PARTS & SERVICE NEWS

REF NO.	AA01053
DATE	February, 09, 2001

SUBJECT: BODY PIVOT CASTING

APPLICATION: Komatsu 930E Dump Trucks AFE48- A & up, A30019 & up

FIGURE 1. WELD REPAIR LOCATION AND SPECIFICATIONS

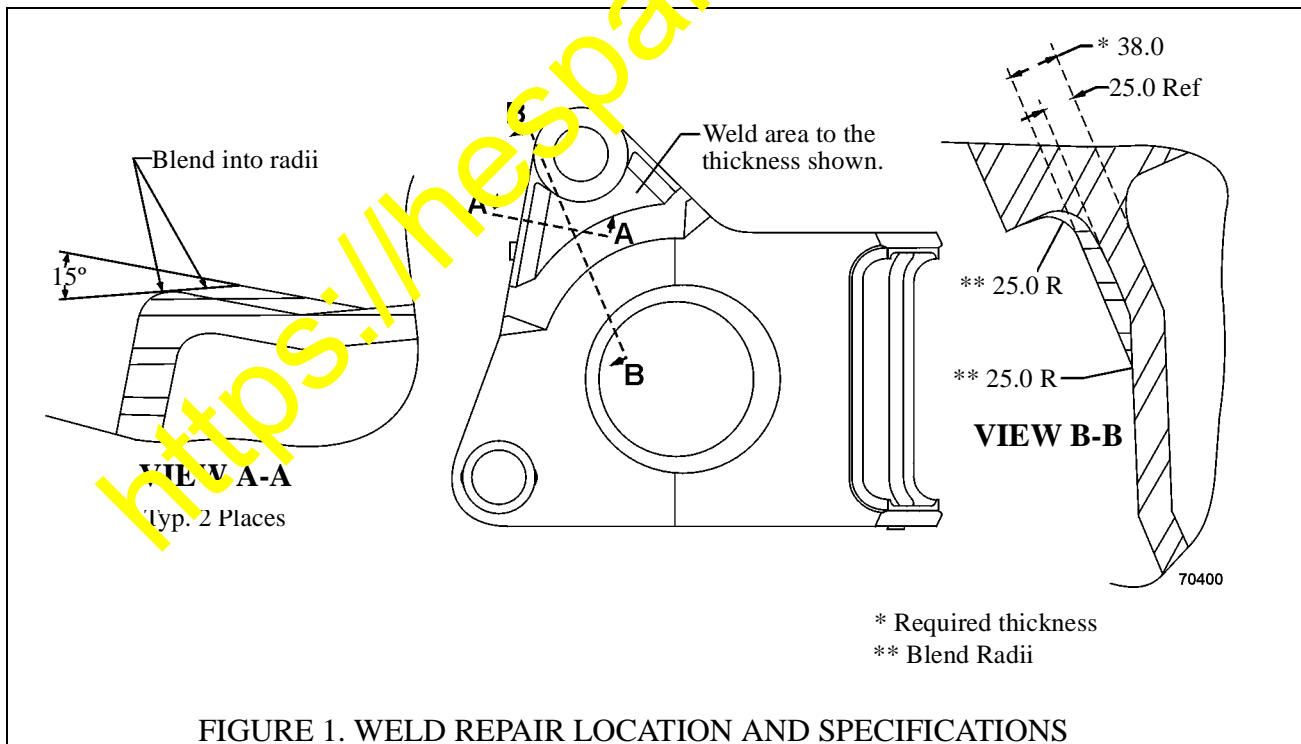
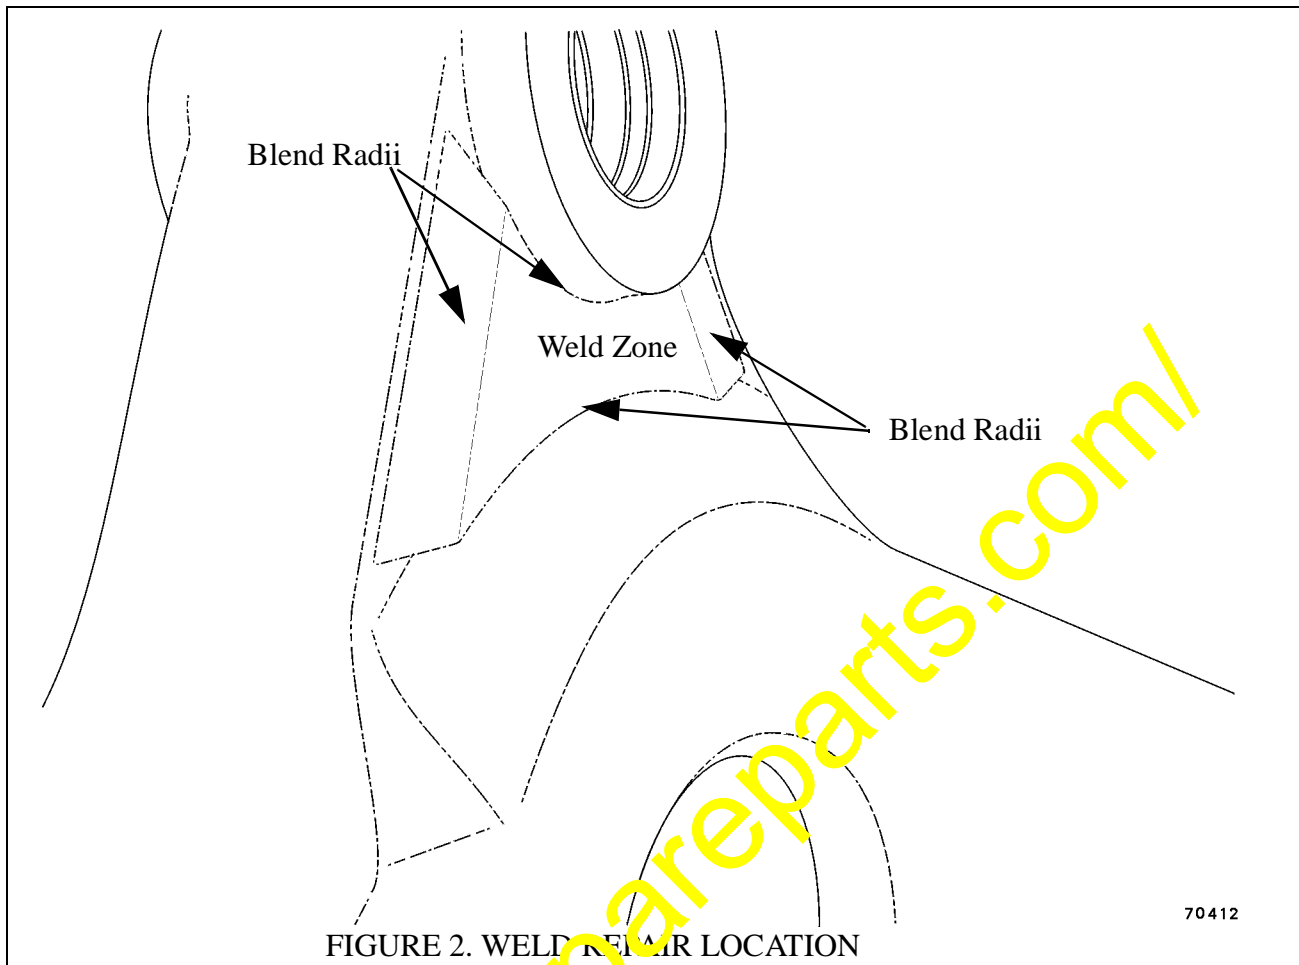
Some trucks in the field have experienced cracking near the rear body pivot castings due to thin casting walls. This approved procedure is intended to pad weld the walls of the castings in order to prevent further cracking in this area. Follow the proceeding instructions and specifications in order to repair the castings.

2. Pre-heat the welding area to 250° F (121° C).
3. Use E7018, 5/32 in. weld wire.
4. Weld the casting using small beads.
5. Hammer peen the weld with a 0.25 in. radius tool after each pass.
6. Post heat the weld area plus an additional 3in. (76.2 mm) to 1000° F (538° C).
7. Grind the toe of the weld in order to form a smooth transition with the casting.
8. Perform a magnetic particle inspection (MPI) on the welded area plus an additional 0.25 in. (6.35 mm). Repair any defects if necessary.
9. Replace the bushing in the body pivot bore.
